# City of Raleigh

## 152-17-CA

## APPLICATION FOR A CERTIFICATE OF APPROPRIATENESS – STAFF REPORT

152-17-CA      506 COLE STREET

506 & 506a Cole Street, Riedeman Residence & Flat, Response to COA Staff comments, 2017-10/26

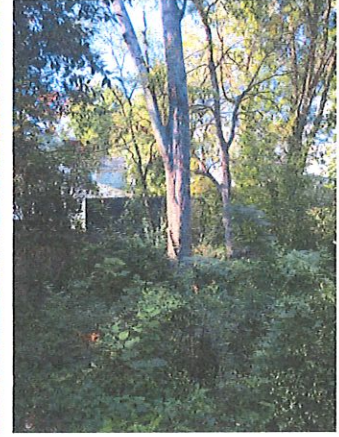
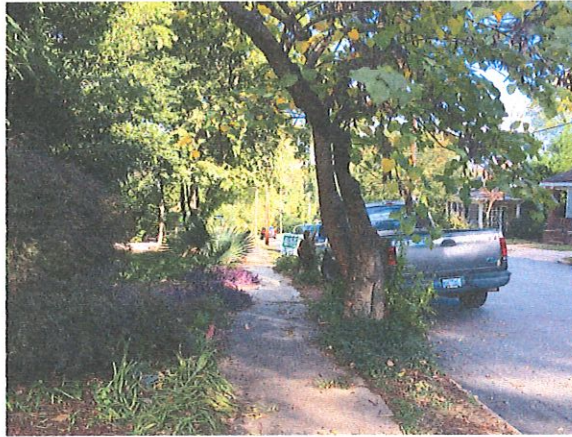
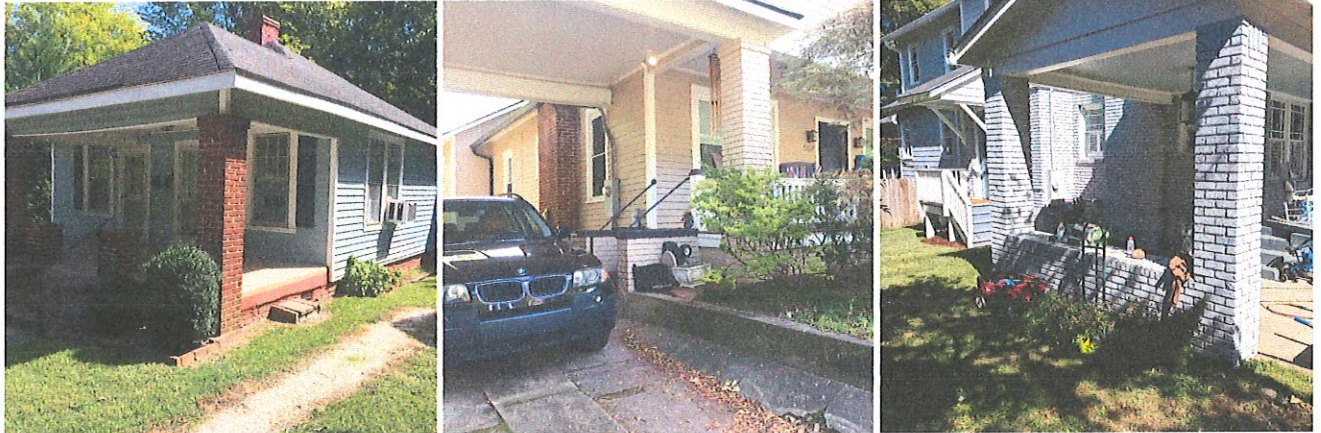
- 1\* A written description of existing trees was provided **along with a site plan identifying one 12" dbh Mimosa Tree and one 16" dbh Redbud tree. The Mimosa is proposed for removal, the Redbud in the right-of-way is to be retained. No replacement tree was specified.**

- 5\* No tree protection plan was provided, although the applicant stated that "All trees and landscaping designated for protection will be cordoned off appropriately throughout construction."

- A. 1-7 TREES and LANDSCAPING: Removal of trees noted on site plan, including 20" oak along west property line towards rear of property, 16" redbud at street (also pending Raleigh arborist review), near-dead 12" crepe myrtle near middle of west property line, and 14" Mimosa on west side of front yard. Also noted are removal of row of neglected shrubs and < 8" trees along east property line (also pending neighbor's approval). In our opinion, these trees were not intentionally planted and do not contribute to the character of the neighborhood. That said, given the storm loss of the 48" oak, a replacement hardwood has been noted towards the end of the driveway, as a replacement. Front yard landscaping, including Japanese Maple and 20' tall evergreen hedge, will be protected and expanded/infilled, where walkway and steps are removed. Tree protection, construction, and silt fencing noted on site plan.

Crepe myrtle, redbud, and oak to remove to remove.

East property line to clear.

Japanese maple, hedge, and garden to remain and infill gaps.

Side steps used across the street, contributing properties 503, 507, and 508 Cole.

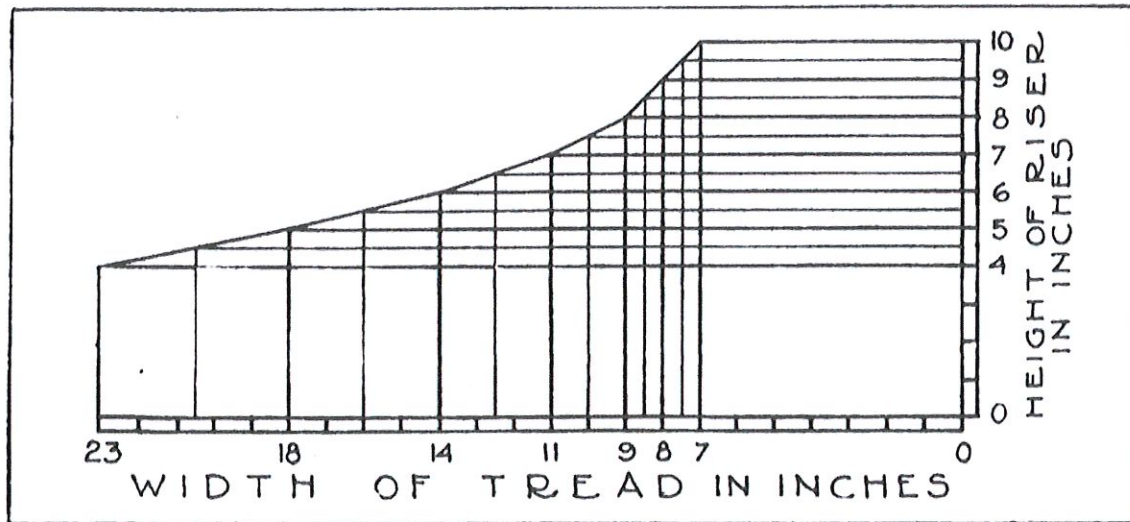
- 18\* The proposal includes a front porch that is at the same level as the main level of the house that is accessed via a stair that leads directly from the driveway.

- 10\* It appears that the front walkway will be removed. From *Design Guidelines* section 1.5 Walkways, Driveways, and Off-street Parking, page 26: "In Raleigh's pre-World War II

- A. 8-12 DRIVEWAY, BUILT/OPEN SPACE, WALKWAY, and STEPS. Driveway noted on site plan. Built area to open space analysis noted on site plan. New house footprint closely follows original, with the exception of slight elongation of the "addition" in order to provide better shape/form to the resulting open spaces (parking/driveway/entry court and backyard). The driveway may be of salvaged brick (arranged with horizontal gaps for permeability, traction, and plantings) or pea gravel, similar to the original. Walkway will be removed in order to consolidate vehicular and pedestrian paths and reinforce actual usability patterns of neighborhood and best stair practices (for then and now) for safe, comfortable ascent.

VERTICAL DETAIL, EAST (MAIN EAVE)

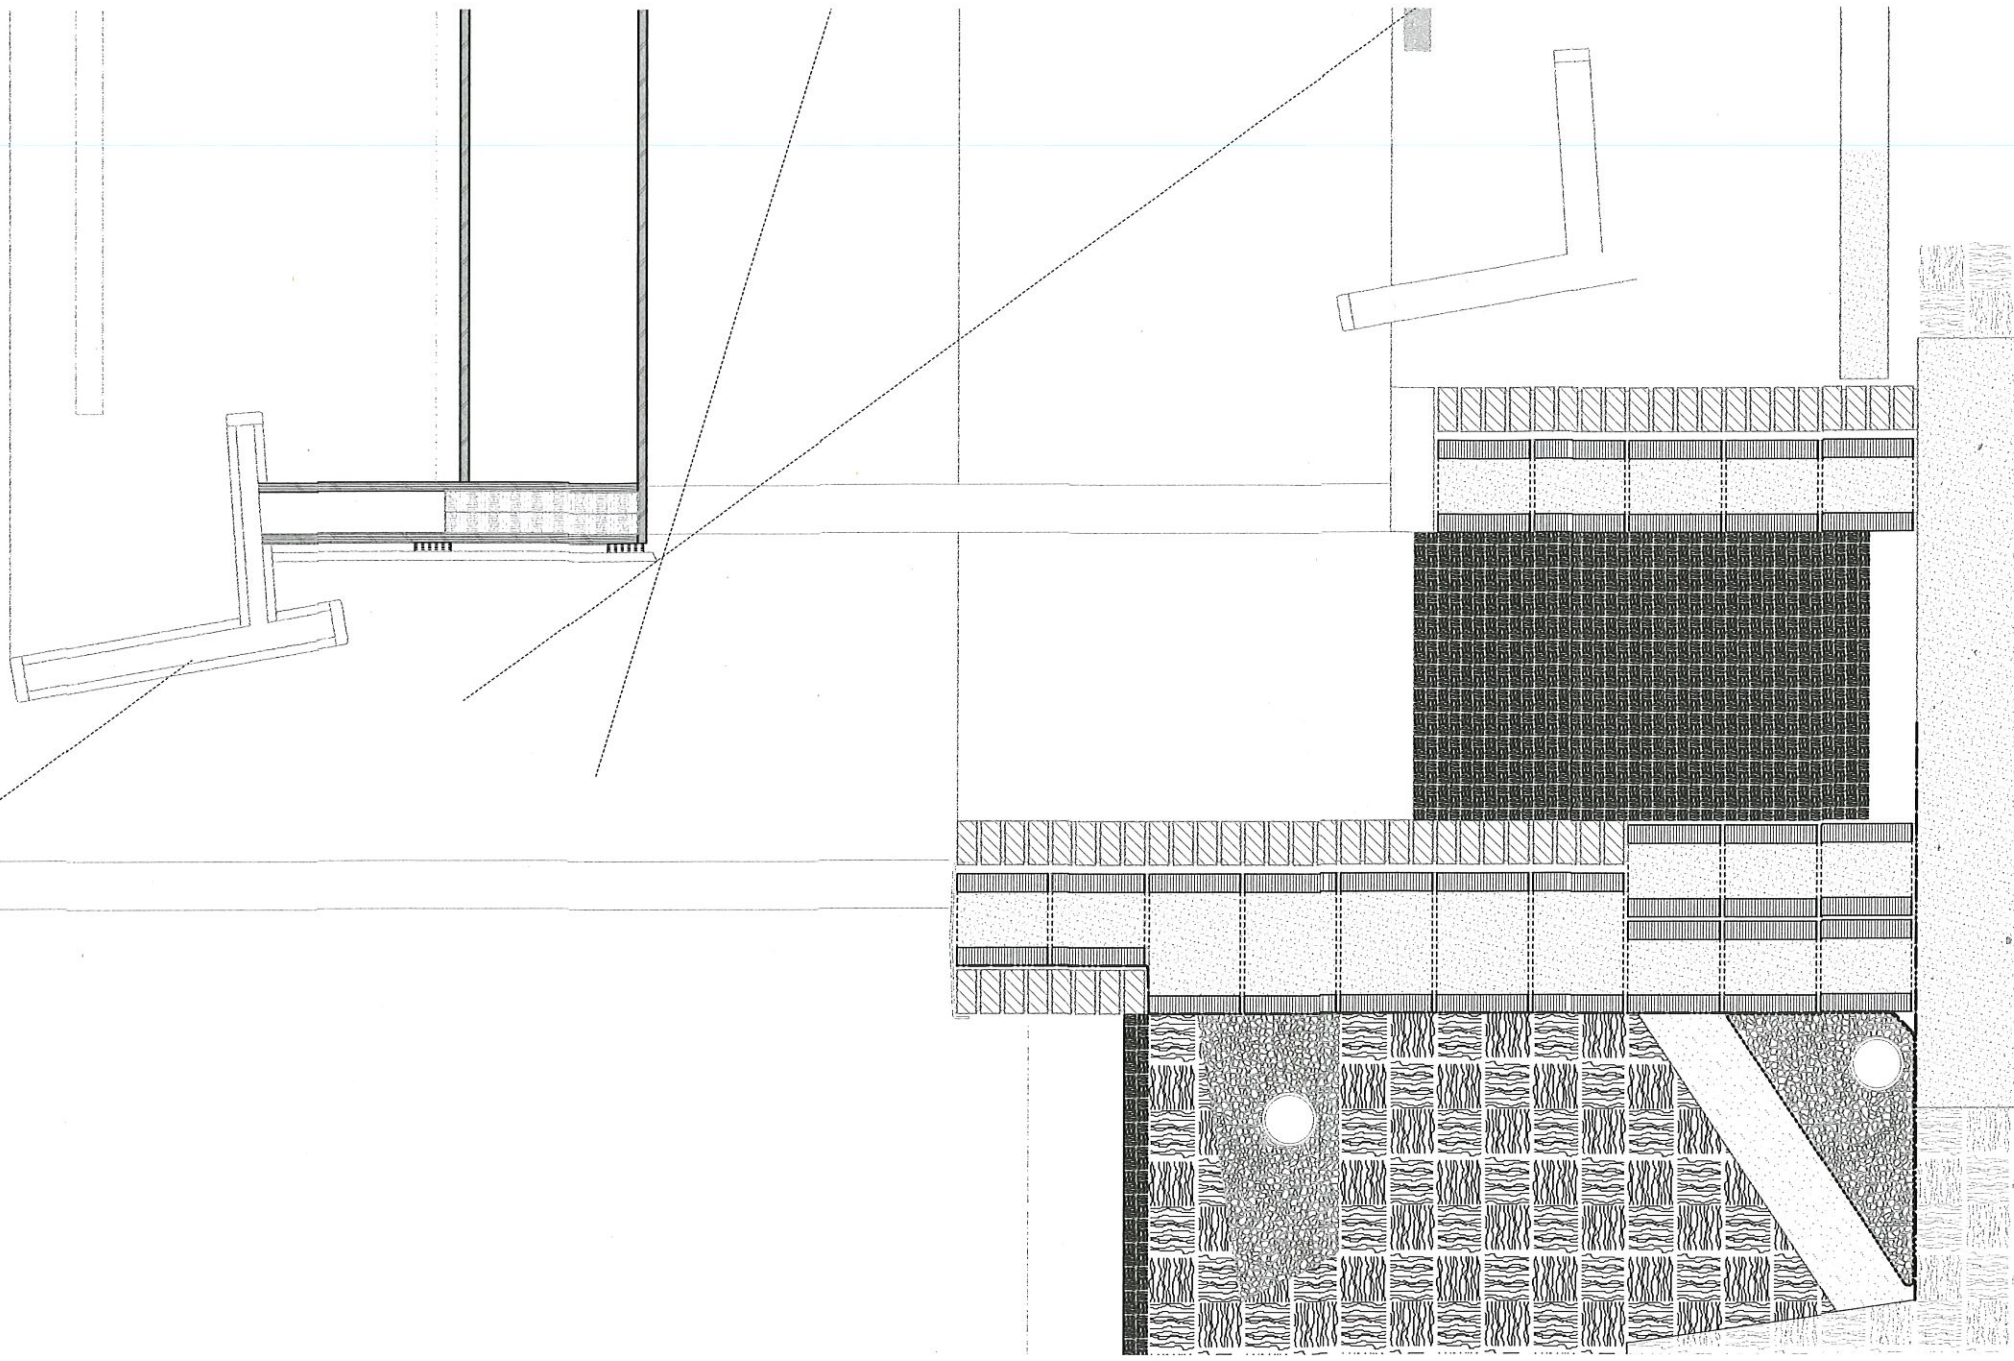
- 21\* Stone and masonry retaining walls are not uncommon in the Glenwood-Brooklyn Historic District.
- 22\* **A detailed drawing of the eave design was provided. The eave is a simply detailed sloped soffit reminiscent, but not duplicative of a historic eave.**

PREVIOUS SETBACK

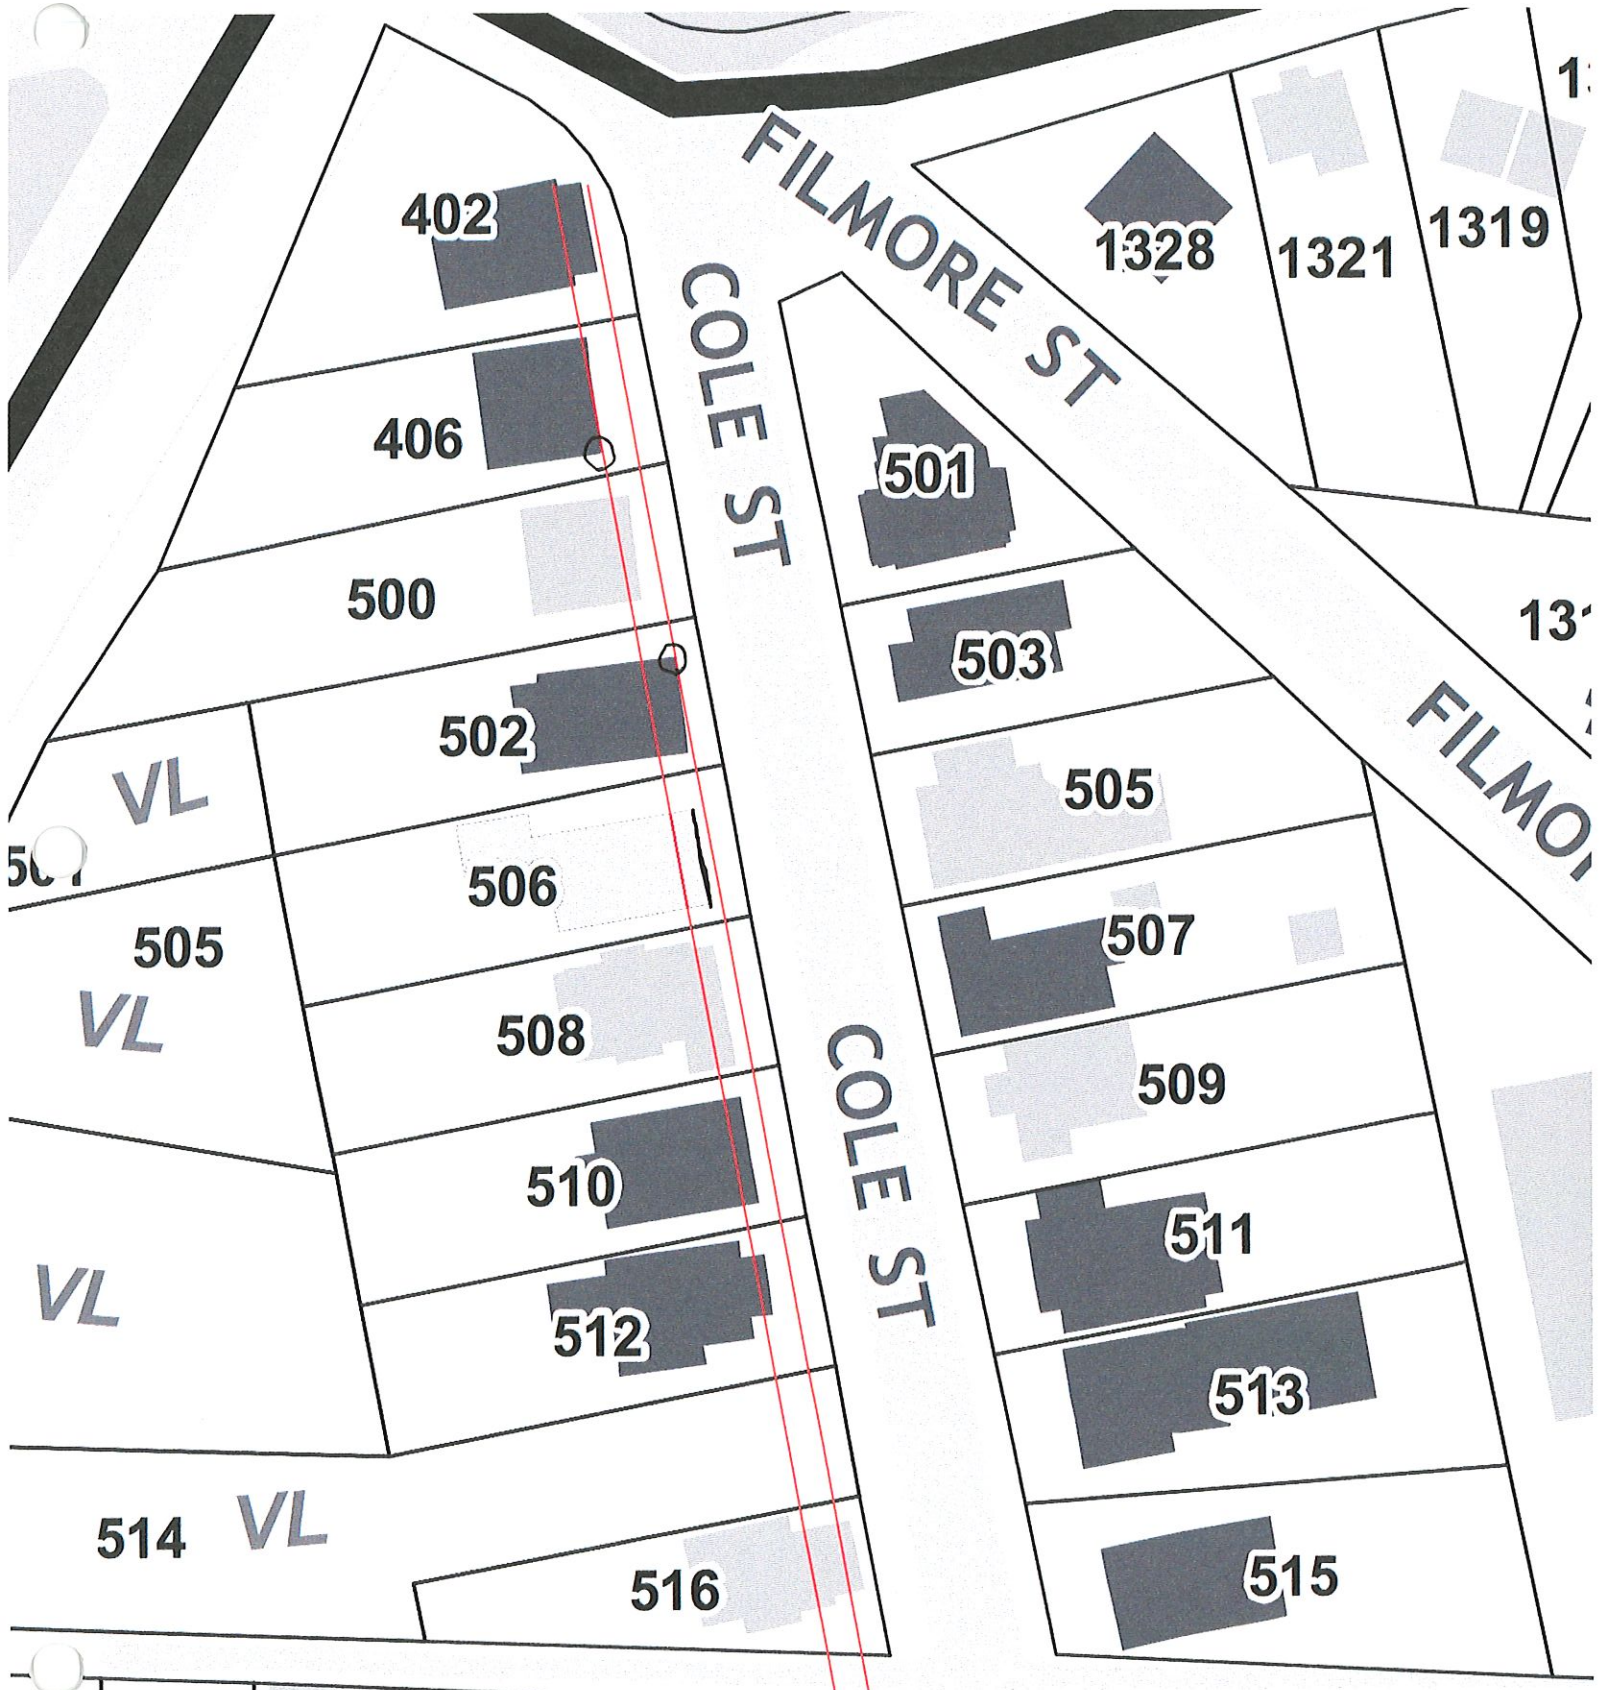
- 4\* There are three important elements of a house that are relevant to setbacks and uniformity in the historic district: the front wall, the porch, and the roof eave. No detailed site plan was submitted, but the front wall of the first level of the house appears to be in line with the adjacent houses. The design of this house makes determining the setback challenging: the

front porch, front wall of the main level and front wall of the second level are all in different planes. Photographs of the streetscape were not provided.

- 5\* **A site plan that includes the adjacent houses provides the setbacks of the front walls and porches. The front of the porch of the proposed new house is within inches of the setbacks of the porches of the adjacent houses. The front wall of the second level is setback the same as the front wall of 502 Cole Street and similar to 508 Cole Street. The wall of the main level is set back an additional 5 feet under the porch roof.**

Staff Evidence: 152-17-CA, 506 Cole St

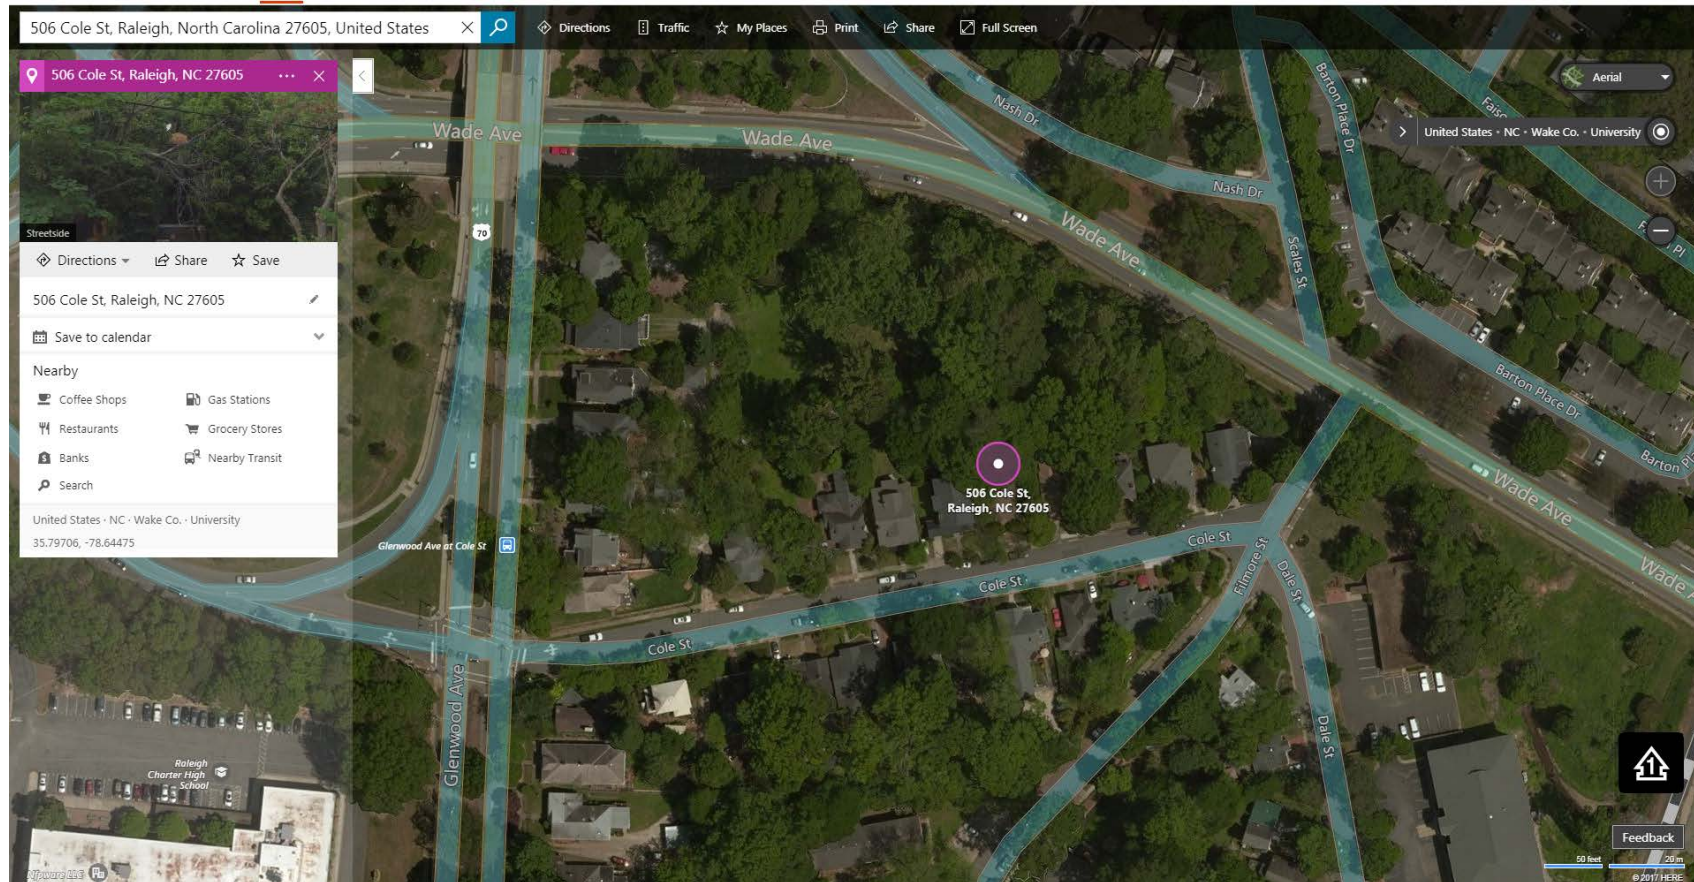
- 2\* Aerial views of the property show a dense tree canopy, although it is unknown how much of the canopy is from a tree that was removed after Hurricane Matthew in 2016. See staff evidence for an aerial view from Bing maps.
